# Access Compliance Report

## Public Rights-of-Way

Intersection ID: 14633	Main Street: E_KINGSTON_AV	Cross Street: PARK_RD	Location:	N
ADA ID: 66C0B886EE0E	Ramp Type: Perp	Initial Pass/Fail: Fail	Overall Compliance: No	Severity Score: 1.25

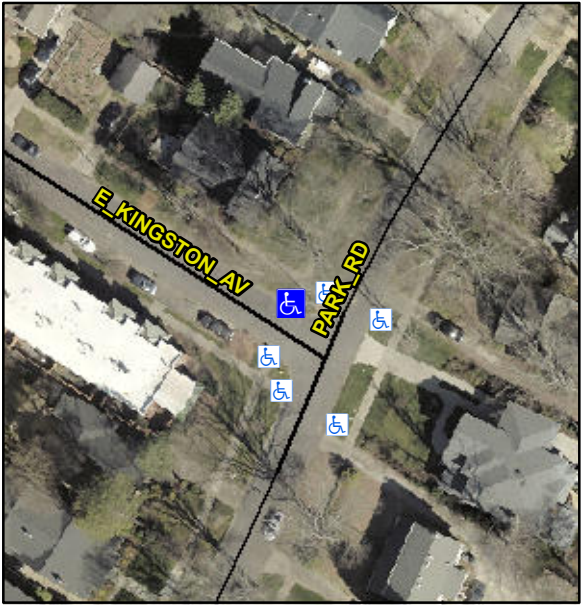
Codes/Mitigation Info/Possible Solution		Field Measurements/Component Compliance					
	Possible Solutions:	<b>Remove &amp; Replace Entire Ramp.</b>					
	Surveyor Notes:	N/A					
	PROW/ADA:	Not Found, R304.5.3					
	Street 1 Name	E KINGSTON AV					
	Stop Condition-Street 2	StopSign					
	Street 2 Name	N/A					
	Stop Condition-Street 1	N/A					
	Total Cost:	\$ 1850.00					
		Compliance	Description	Data	Compliance	Description	Data
		N/A	Ramp Length (in)	51.0	Yes	Ramp Slope (%)	7.6
		Yes	Ramp Width (in)	48.0	No	Ramp XSlope (%)	2.7
		N/A	Flare Type LT	N/A	N/A	Flare Type RT	N/A
		N/A	Flare Slope LT (%)	N/A	N/A	Flare Slope RT (%)	N/A
		N/A	Flare Traversable LT?	N/A	N/A	Flare Traversable RT?	N/A
		N/A	Landing Length (in)	N/A	N/A	DWS Provided?	N/A
		N/A	Landing Width (in)	N/A	N/A	DWS Contrast?	N/A
		N/A	Landing Slope (%)	N/A	N/A	DWS Length (in)	N/A
		N/A	Landing X Slope (%)	N/A	N/A	DWS Full Width?	N/A
		N/A	Landing Curb? (Y/N)	N/A	N/A	DWS Offset (in)	N/A

N/A	Shared Landing?	N/A			
		N/A	Gutter Ponding?	Yes	N/A	Gutter Slope (%)	N/A
		N/A	Gutter Lip Ht (in)	N/A	N/A	Gutter X Slope (%)	N/A
		N/A	Painted X Walk1?	No	N/A	Painted X Walk2?	N/A
			X Walk 1 Direction	To SW		X Walk 2 Direction	N/A
		N/A	X Walk 1 Width (in)	N/A	N/A	X Walk 2 Width (in)	N/A
			X Walk 1 Slope (%)	8.0		X Walk 2 Slope (%)	N/A
			X Walk 1 X Slope (%)	2.2		X Walk 2 X Slope (%)	N/A
		N/A	Ramp inside XWalk1?	N/A	N/A	Ramp inside XWalk2?	N/A
			Road Slope (%)	N/A	N/A	Clear Space?	N/A
			Road X Slope (%)	N/A	N/A	Clear Space to XWalk (in)	N/A
		N/A	Any Obstructions?	N/A	N/A	Storm Grate/Utility Hazard?	N/A
			Obstruction Type			Storm Grate/Utility Type	
				N/A			N/A
					Yes	Surface Condition? (G/P)	Good
